ITEM: 6.6	COMMITTEE OF ADJUSTMENT REPORT SUMMARY MINOR VARIANCE APPLICATION FILE NUMBER A113/23 133 DONHILL CR, KLEINBURG
------------------	--

**COMMITTEE OF ADJUSTMENT REPORT
MINOR VARIANCE APPLICATION
A113/23
133 DONHILL CR, KLEINBURG**

To: Christine Vigneault, Committee of Adjustment Secretary Treasurer
From: Nancy Tuckett, Director of Development Planning
Date: September 14, 2023
Name of Owner: Sabrina Gallo
Location: 133 Donhill Crescent
File No.(s): A113/23

To: Committee of Adjustment
From: Sarah Scauzillo, Building Standards Department
Date: August 24, 2023
Applicant: Ian Robertson Design
Location: 133 Donhill Crescent
PLAN M1230 Lot 60
File No.(s): A113/23

LOT R60
133 DONHILL CRESCENT
FILE NO. A113/23

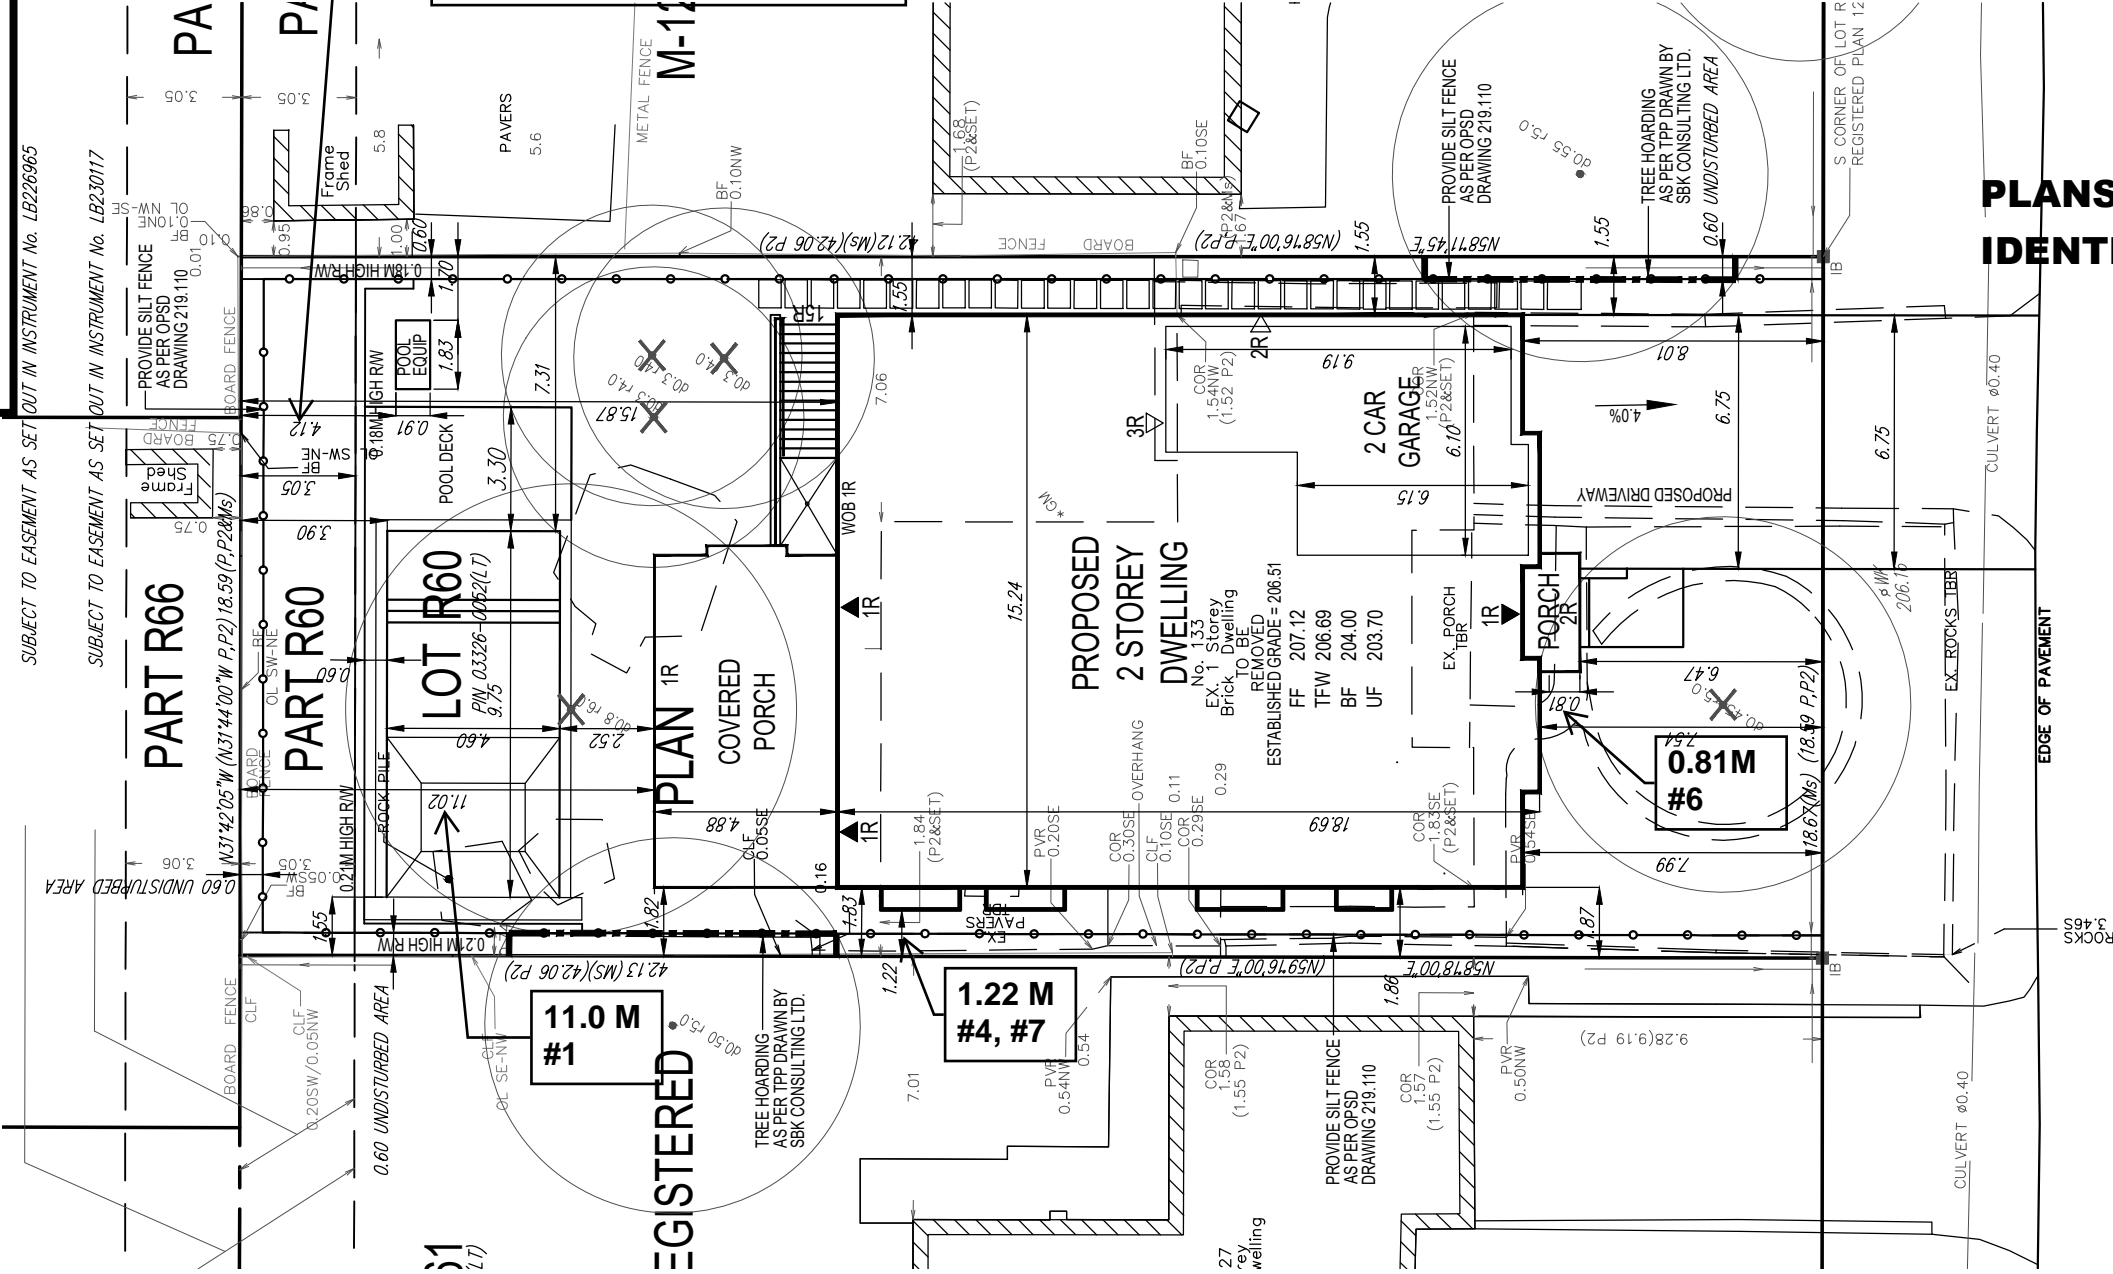
The proposed dwelling, covered rear yard porch, and covered front porch will have lot coverages of 35.85%, 5.56% and 0.56% respectively. The 1.97% increase to the permitted lot coverage is minor in nature, appropriate for the size of the lot and will not pose a significant adverse impact to the neighbouring properties or the surrounding area. The minor increase in lot coverage is to facilitate the construction of the single storey rear yard porch, which is considered non-habitable space. The proposed increase in lot coverage is also in line with previous approvals for dwellings with covered porches in the neighbourhood. As such, the Development Planning Department has no objection to Variance 2 for the increased lot coverage.

The Development Planning Department has no objection to Variances 4 and 7. The variances pertain to four window wells, identified as 'retaining walls' within the north interior side yard. Deeper window wells are proposed to facilitate the installation of taller basement windows. The retaining wall height is measured from the bottom of the window wells to the top of the finished ground floor, so the vast majority of its height would be hidden from view. The retaining wall is not anticipated to have adverse impacts to the neighbouring property to the north. The Development Engineering Department has also reviewed the proposal and is satisfied that drainage in the interior side yard will be maintained.

The Development Planning Department has no objection to Variances 5 and 8 for the proposed pool equipment as the proposal maintains sufficient area for access and maintenance and is not anticipated to adversely impact the neighbouring properties. The Development Engineering Department has also reviewed the proposal and is satisfied that drainage will be maintained.

SHEET TITLE: **FRONT ELEVATION**
 PROJECT NUMBER: **23-02**
 SCALE: **1/8" = 1'-0"**
 DRAWN BY: **MF**
 DRAWING NO.: **5 OF 8**

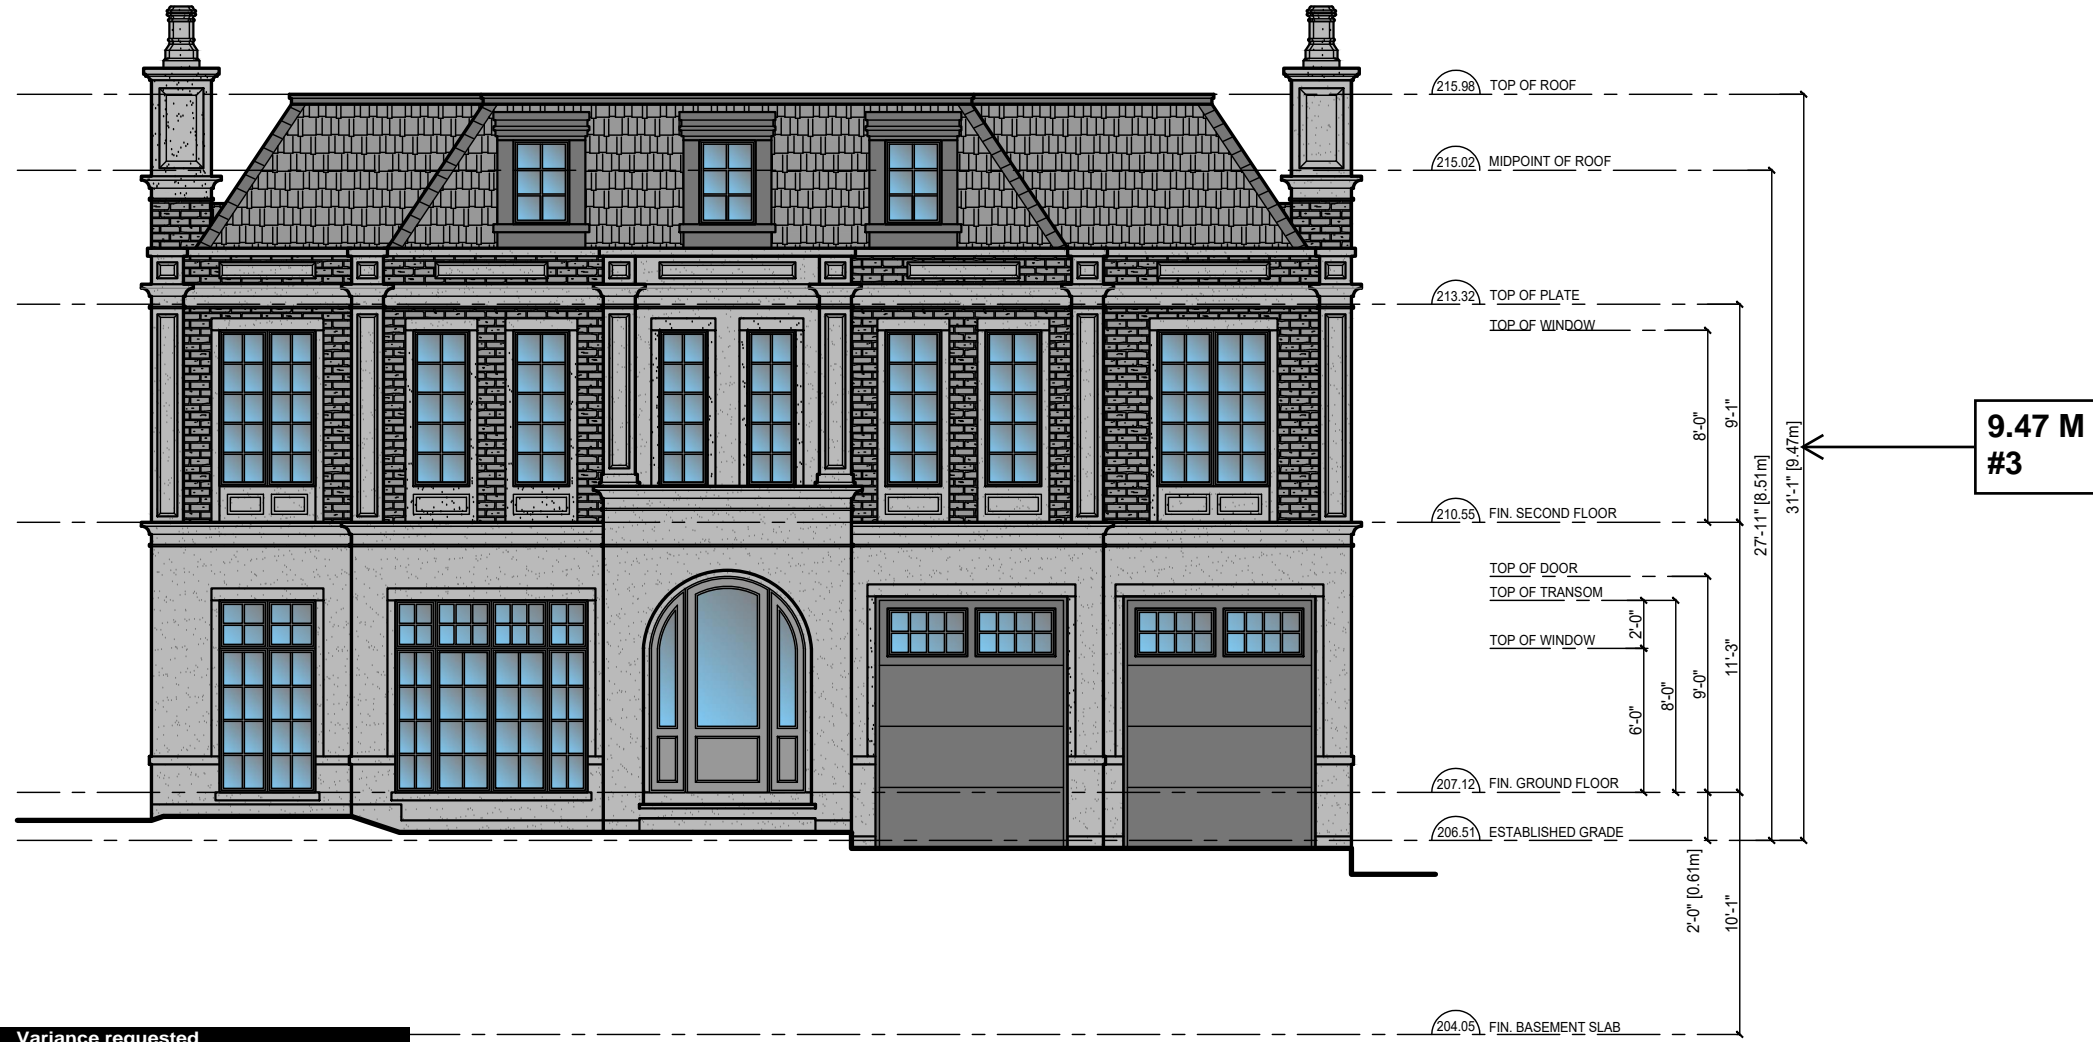
General Comments	
1	Applicant to update the front elevation drawing to include the proposed building height in accordance with Section 3.0 of By-law 001-2021.
2	The minimum required rear yard setback of 12.0 metres is required to the below grade living space under the rear covered porch. [Table 7-3]
3	Zoning By-law 001-2021 as amended is in force however sections of the By-law have been appealed. By-law 1-88 is also applicable for all appealed sections. Relevant to this review: Section 4.13 of By-law 001-2021 has been appealed and therefore Section 3.14 of By-law 1-88a.a. is applicable.
